City of Port Moody Report/Recommendation to Council

Date: October 29, 2021
Submitted by: Community Development Department – Development Planning Division
Subject: Official Community Plan Amendment – Coronation Park (Wesgroup Properties)

**OCP COMMENT
RESPONSE
PACKAGE**

TOWER HEIGHT (STOREYS)

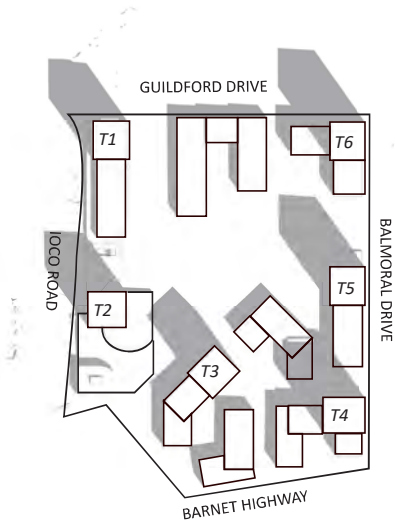
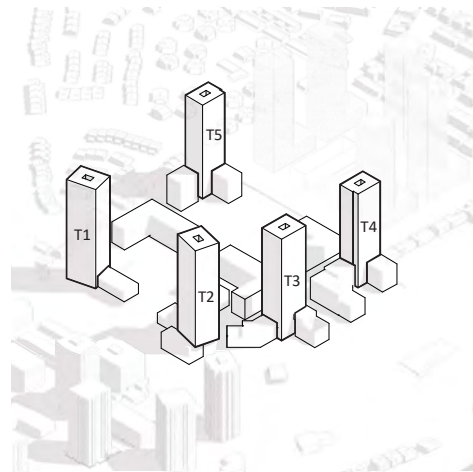
1.2	Pull back project residential density to closer alignment with the community plan vision, with most towers not to exceed 26 storeys.	One 31-storey tower added mid-way along Balmoral Drive.

BEFORE	AFTER
T1	40	26
T2	40	26
T3	40	26
T4	37	31
T5	37	31
T6	N/A	31

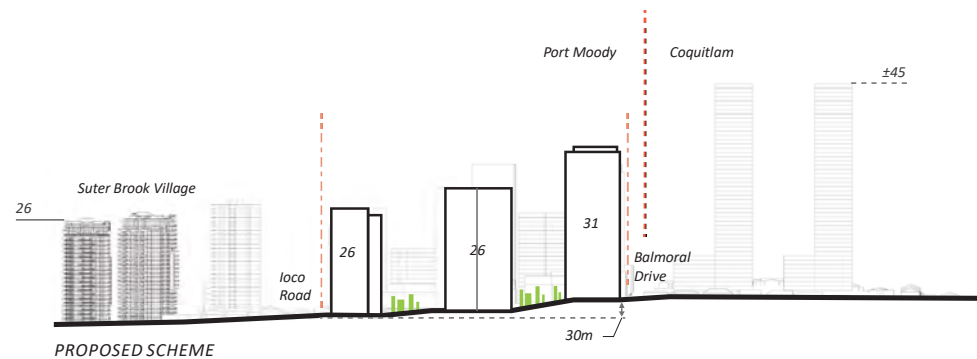
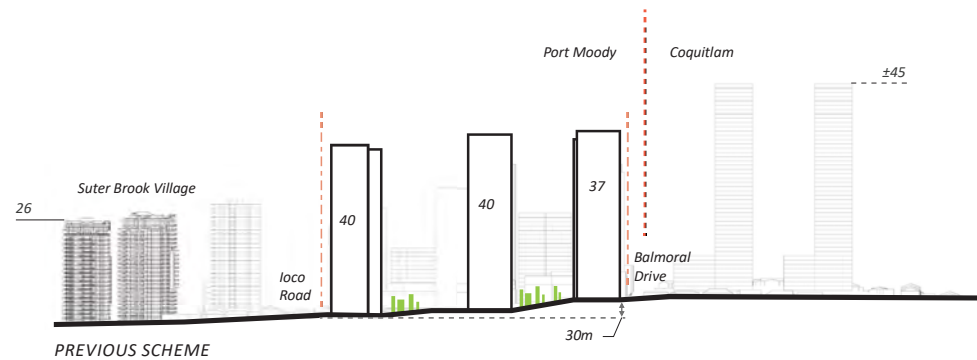
ITEMS:	CITY COMMENTS:	ACTIONS/RESPONSES:
1.3	Explore reconfiguration of towers from east to west with taller towers situated to the east	Towers are now stepped down from east to west.

CURRENT PROPERTY HOLDOUTS

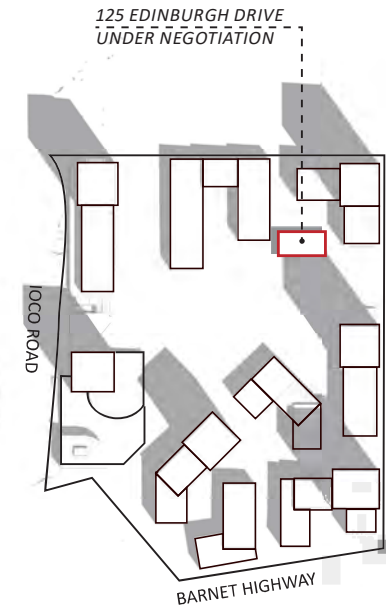
ITEMS:	CITY COMMENTS:	ACTIONS/RESPONSES:
1.5	Ensure that the properties in this part of the neighbourhood that are not part of this application are left with a practical development potential in the future	Significant holdouts on Buckingham have been added to the site plan.

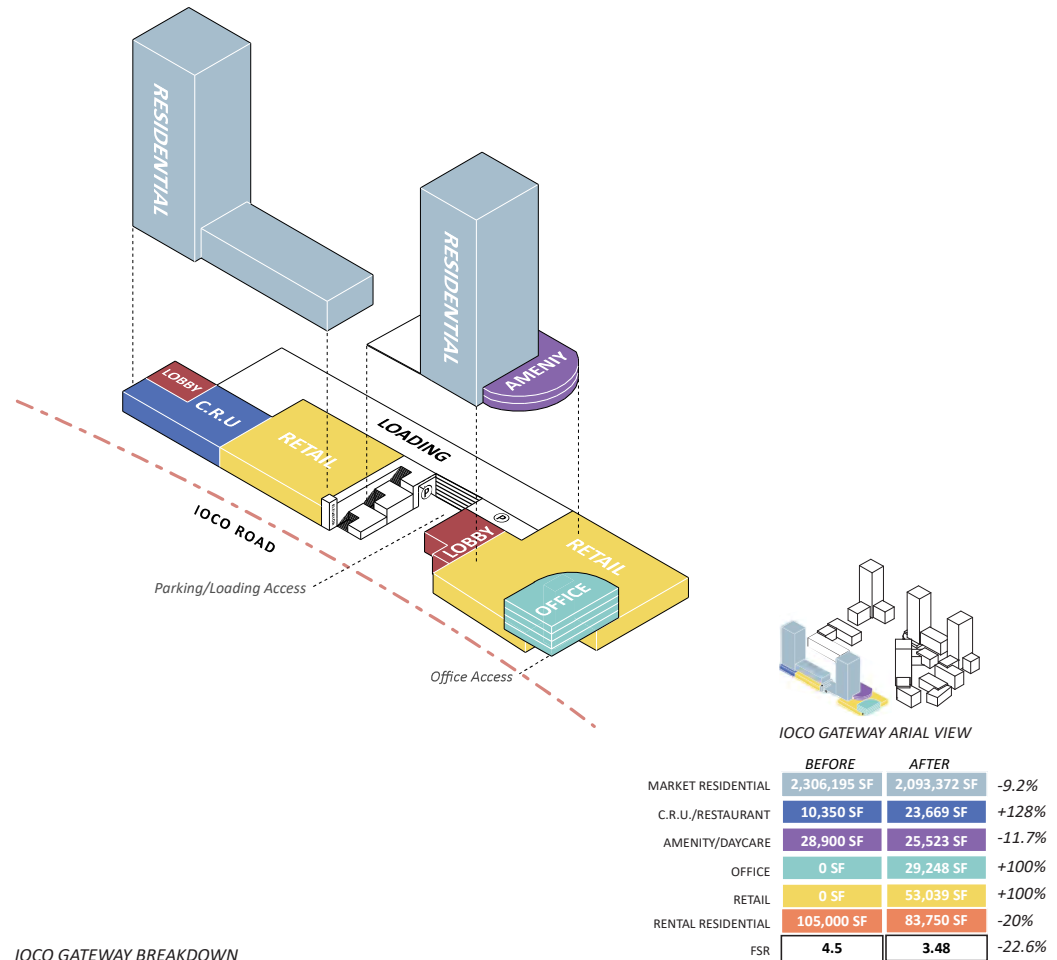
4.2	Increase accommodation of essential local shopping options in light of increased demand from the project	<p>Smaller storefronts are, by nature, more reminiscent of local mom-and-pop shops with the home-grown feeling typical of Port Moody retail. Merchants can often find themselves becoming involved in the community and by tailoring inventory and decor to reflect the region it's located in. Wesgroup is committed to providing these types of retail space.</p> <p>On both Balmoral Drive and loco Road, smaller and fine grained retail is envisioned. This will enhance the diversity of commercial opportunities, and achieve in part, the "high street" character envisioned for loco Road.</p>

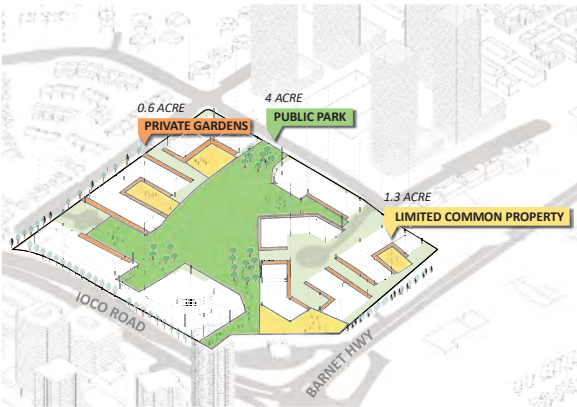
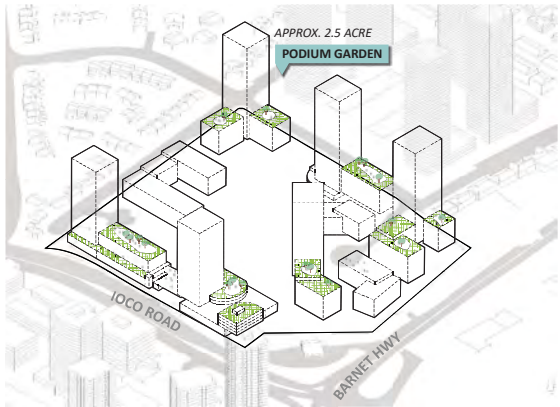
ITEMS:	CITY COMMENTS:	ACTIONS/RESPONSES:
5.1	The amount and configuration of the public park space versus the semi-public open space	Private open spaces are located atop the podiums, serving the residents and office users. Programming will include gardens, lawn areas, children's play areas, outdoor fitness areas, urban agriculture, areas for contemplation, outdoor kitchen, and a variety of social and interactive gathering spaces.

BEFORE	AFTER	
LIMITED COMMON PROPERTY	2.3 ACRE	1.3 ACRE	-43%
PUBLIC PARK	1.5 ACRE	4 ACRE	+160%
PRIVATE GARDEN	0 ACRE	0.6 ACRE	+100%
PODIUM GARDEN	0.42 ACRE	2.5 ACRE	+495%

ROAD NETWORK

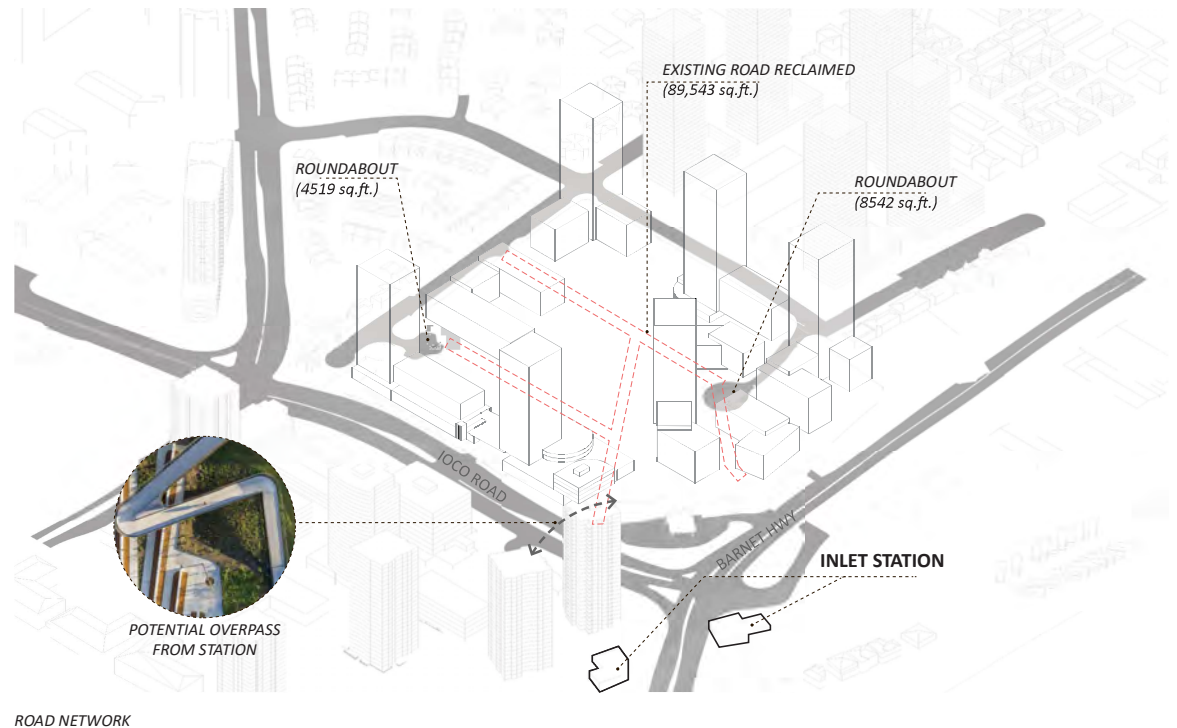
6.3	Conversion of as much existing road network to park as possible.	<p>By moving the towers to the corners of the site, we have converted existing road network to open parks and quieter private roads.</p> <p>87.2% of existing roads removed.</p> <p>The design has been modified to provide more emphasis the South-West corner, including the overpass which Wesgroup is willing to work with the City on. Costs of the overpass to be negotiated out of CAC or other means provided by the City.</p>

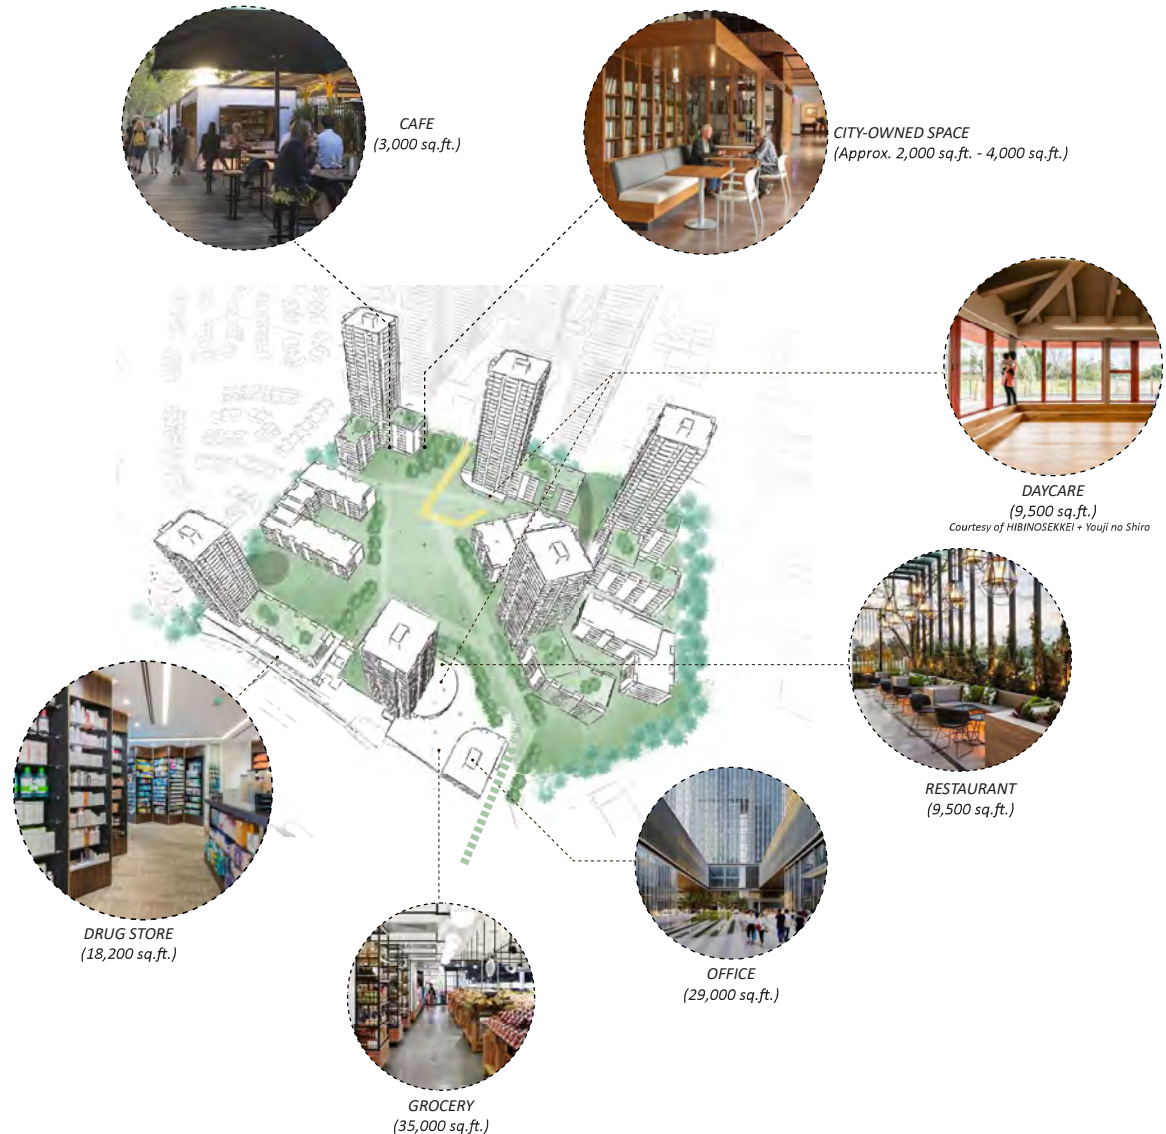
7.4	Staff discuss with the proponent the possibility of building the City purpose-build space (such as a library, seniors' centre, dog park, space identified by staff, performance space, etc.) within the development	<p>Purpose built space is being considered around the central park - potentially as an amenity centre co-located with daycare, outdoor activity, performance space and retail uses.</p> <p>We have allocated turn-key city-owned space in the northeast corner of the site. Size and programming yet to be determined (Approx. 2000 to 4000 sq.ft.).</p>
